Fred Dong – Canyon Hills EIR Comments

Section IV. N AESTHETICS

Figure 45: Summary of observed effects, and the mean levels of the exposure for human studies of exposure to electromagnetic radiation. All epidemiological studies occur below the ICNIRP and New Zealand Standard of allowable exposure.

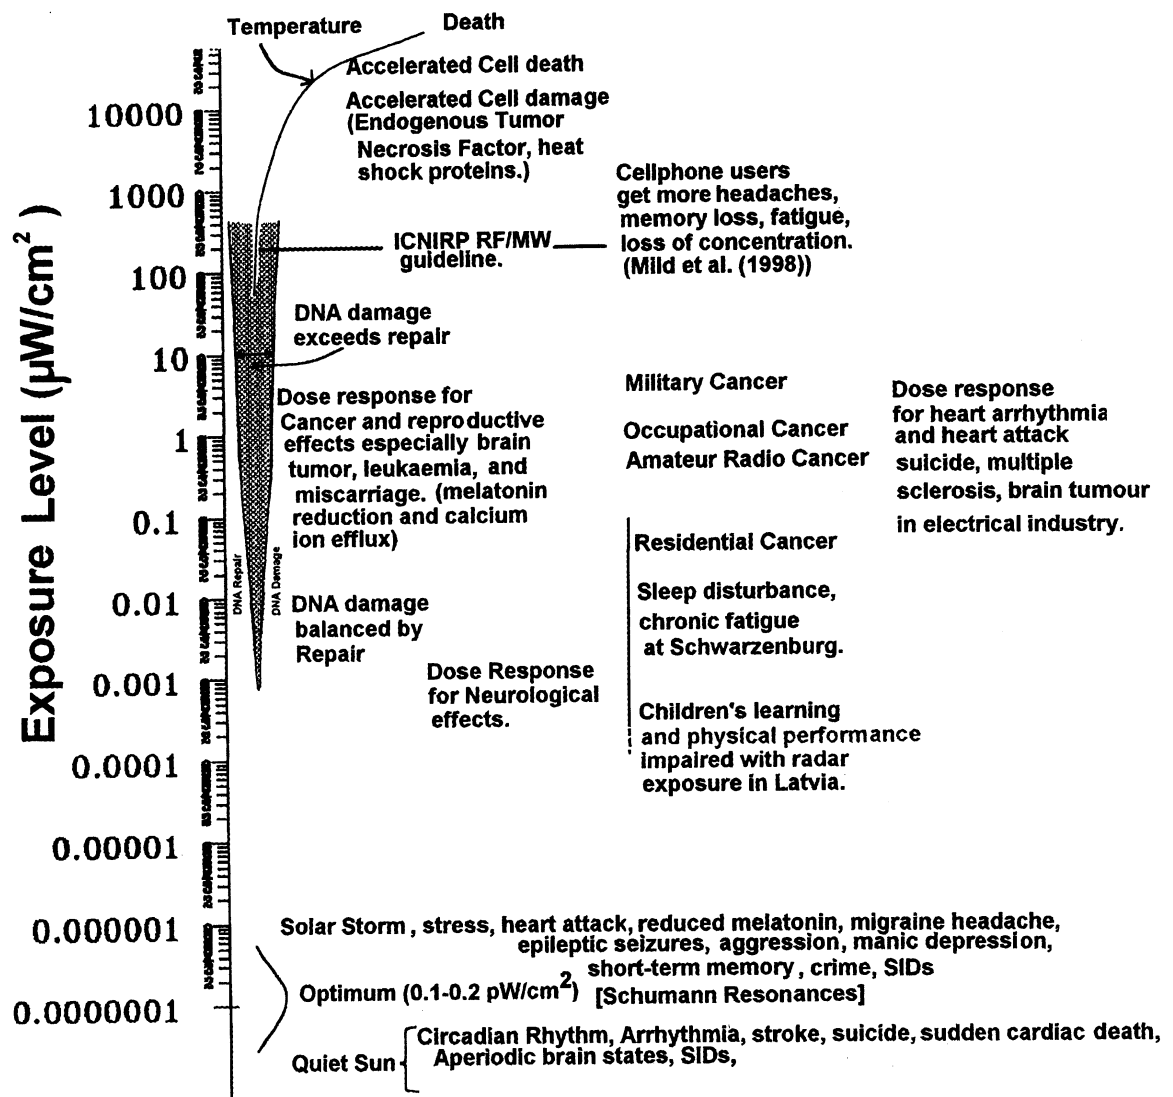
extremely low chronic mean levels, and many dose response relationships are established to prove that these biological effects from EMR exposure is genotoxic. Significant DNA strand breakage has been observed down to $1 \mu W/cm^2$, Phillips et al. (1998), with elevated DNA damage below this. Therefore there is extremely strong evidence that EMR across the spectrum is genotoxic, even at very low exposure levels found in the vicinity of cell sites, Figure 45.
